# LLDP Extensions v120

**Lennart Yseboodt, Matthias Wendt**

Philips Research

September 10, 2015

Figure 79-3—Power Via MDI TLV format

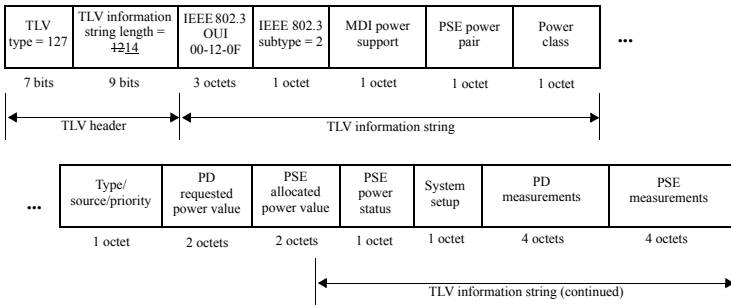
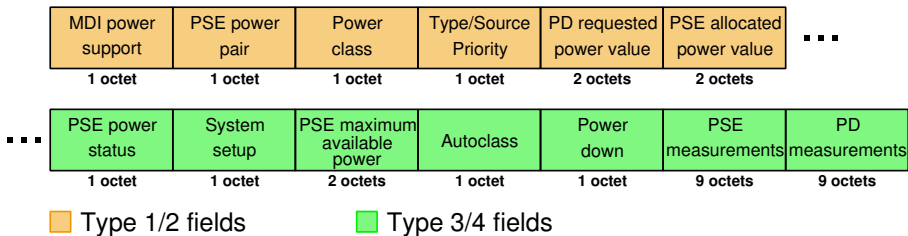
# Dual Signature with Unequal Classes

Replace Figure 79-3 with the following:

This is the current (Draft 1.2) LLDP format. It does not support Dual-Signature PDs with unequal classes on each pairset.
